INNER WEST COUNCIL

DEVELOPMENT ASSESSMENT REPORT

Application No.	D/2018/254
Address	17 Burt Street, ROZELLE NSW 2039
Proposal	Ground floor alterations and additions to existing heritage listed dwelling and garage, including elevated rear decks, and alterations to rear shed to create a studio.
Date of Lodgement	16 May 2018
Applicant	T McLain
Owner	Mrs C E Allibone-White
Number of Submissions	1 submission
Value of works	\$95,000.00
Reason for determination at Planning Panel	Part demolition of Heritage Item
Main Issues	Maintenance access to adjoining wall. Impacts on trees
Recommendation	Approval
Attachment A	Recommended conditions of consent
Attachment B	Plans of proposed development

Number
2520 . DA 05 C

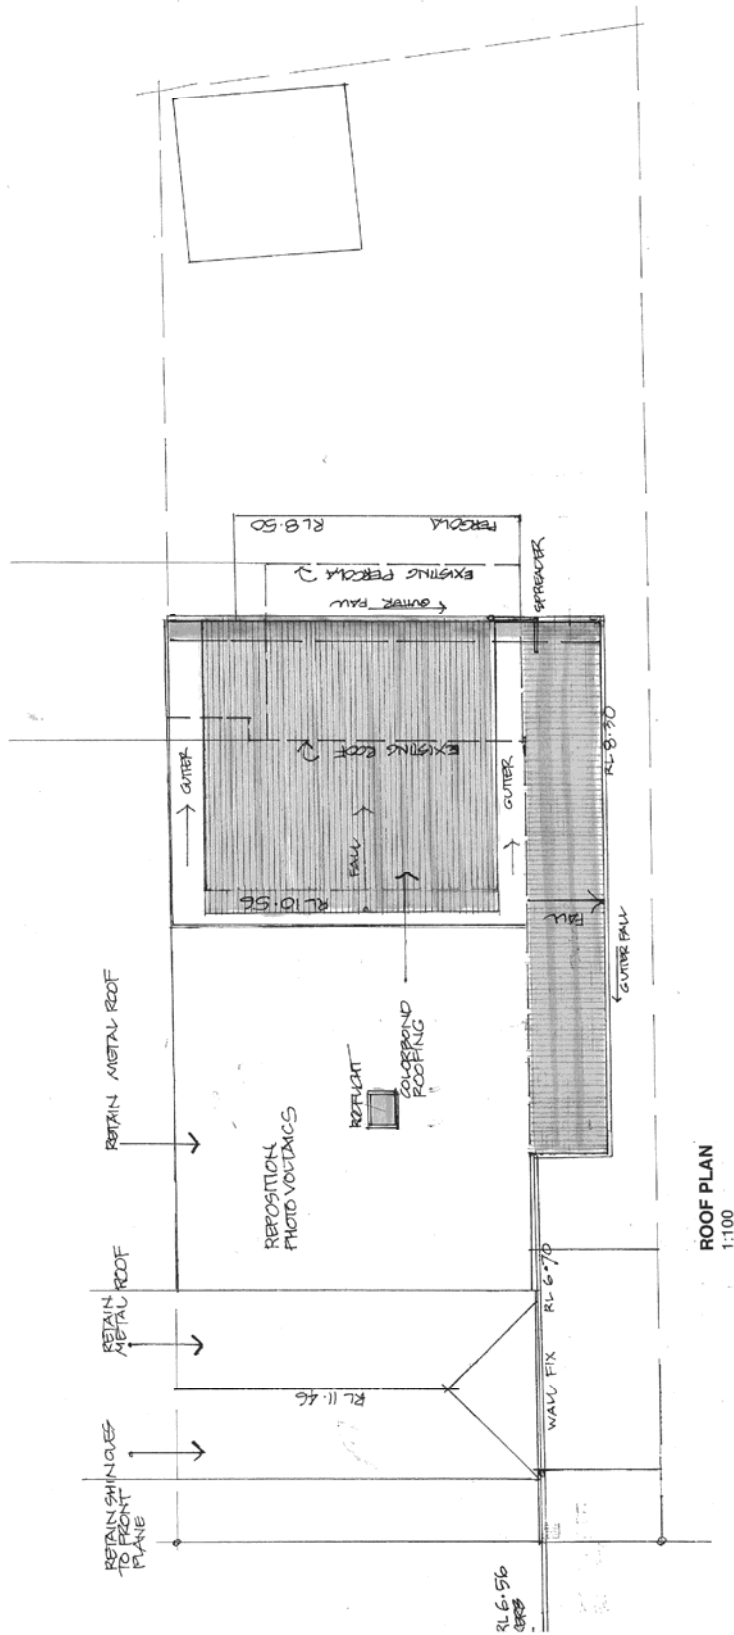
Comment: Applicants have provided a roof/stormwater plan with the application indicating that all stormwater collected from the proposed new roof areas will be collected and drained away to Burt Street by gravity. Standard Engineering stormwater conditions will be imposed on any consent granted.

Project
PROPOSED ALTERATIONS
17 BURT STREET
ROZELLE
 Title
SHADOWS 21 JUNE 3pm

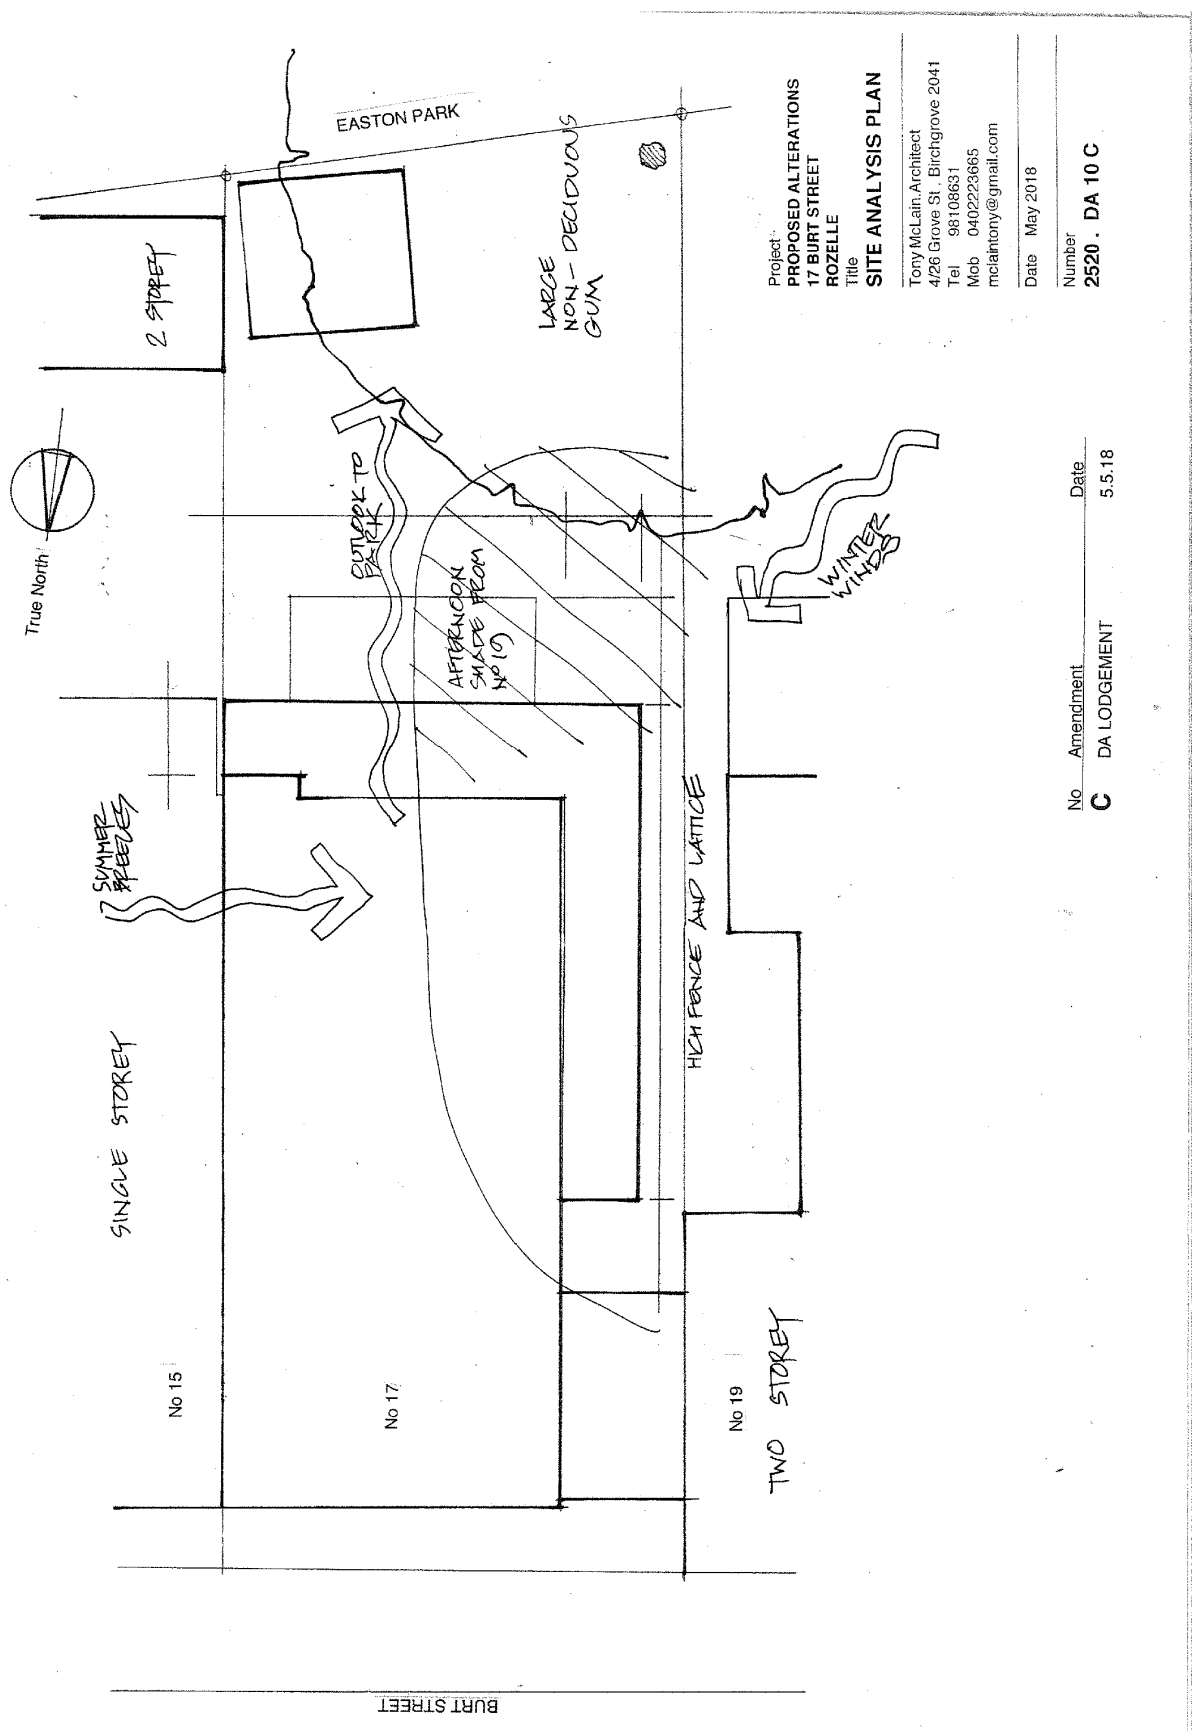
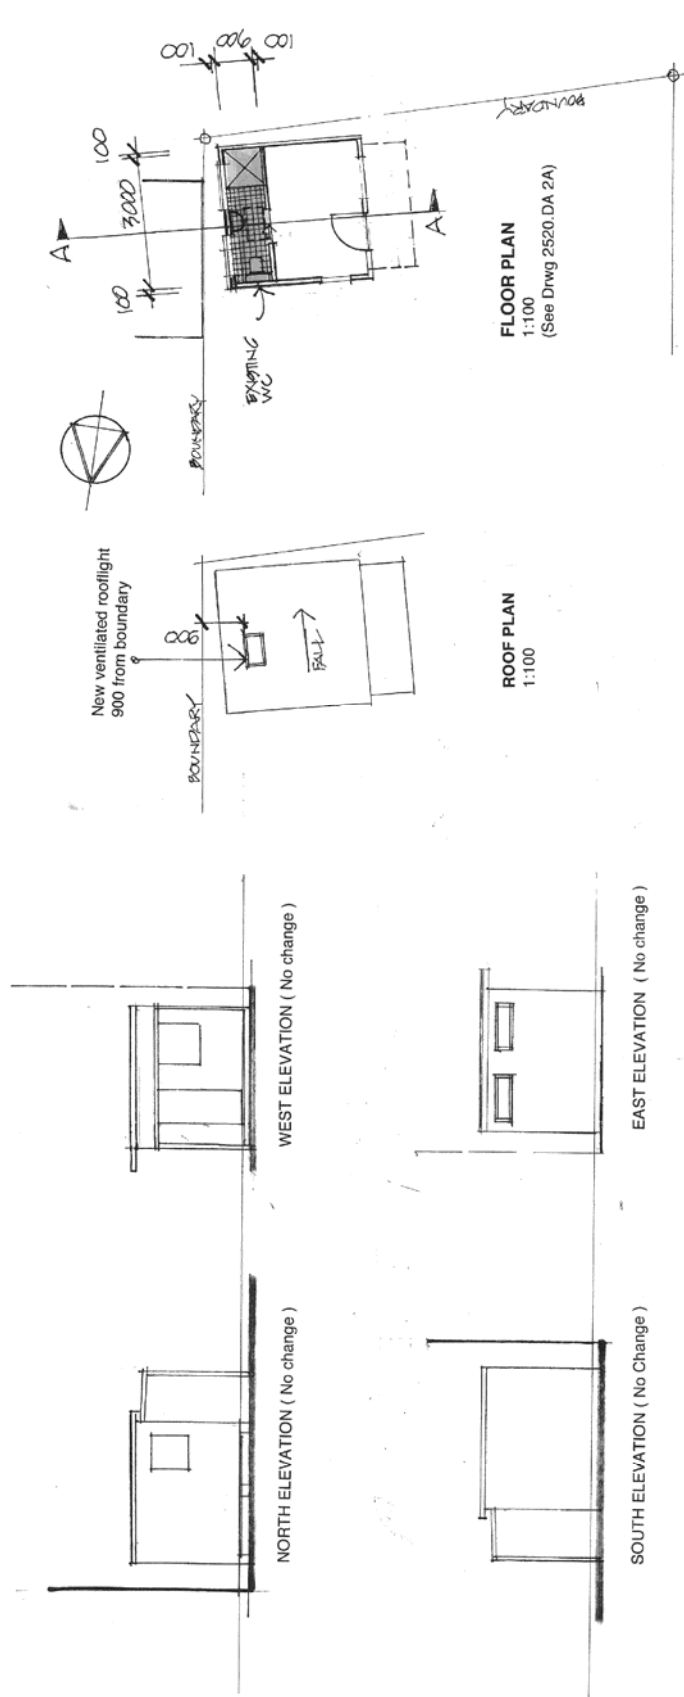
The submitted shadow diagrams suggest additional overshadowing of the adjoining rear yard of No. 15 Burt Street from 1pm to 3pm in the afternoon in mid-winter. Clause 3.9 of the LDCP2013 requires that this adjoining yard area retains solar access for 2 hours to 50% of its area between 9:00am and 3:00pm in mid-winter, and if it already does not meet this requirement, no additional overshadowing impacts are permitted. Given that this adjoining

yard area already does not receive the requisite solar access (2 hours to 50% of its area), the proposed additional overshadowing impacts would be contrary to the provisions of Clause C3.9 of the LDCP2013.
